## Huawei Inverter – AS4777.2:2020 Firmware Compliance Update

For SUN2000-50KTL-M0 and SUN2000-100KTL-M1, these two models has to be manually upgraded to following version to guarantee inverters comply with AS4777.2 2020 standards which takes effect from 18<sup>th</sup> DEC 2021.

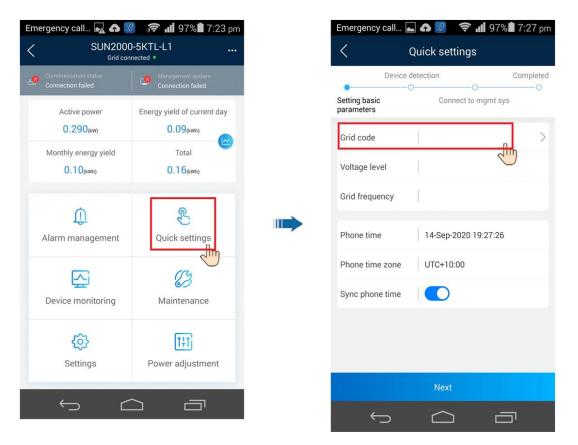
After firmware upgrade is completed, please select the correct grid code from 4 new sets of grid codes (AUSTRALIA AS4777\_A-LV230, AUSTRALIA AS4777\_B-LV230, AUSTRALIA AS4777\_C-LV230, and AUSTRALIA AS4777\_NZ-LV230) based on the region of installation to make inverter fully compliant.

AS/NZS 4777.2:2020 requires inverter shall not operate until a regional setting has been selected and activated by an authorised person.
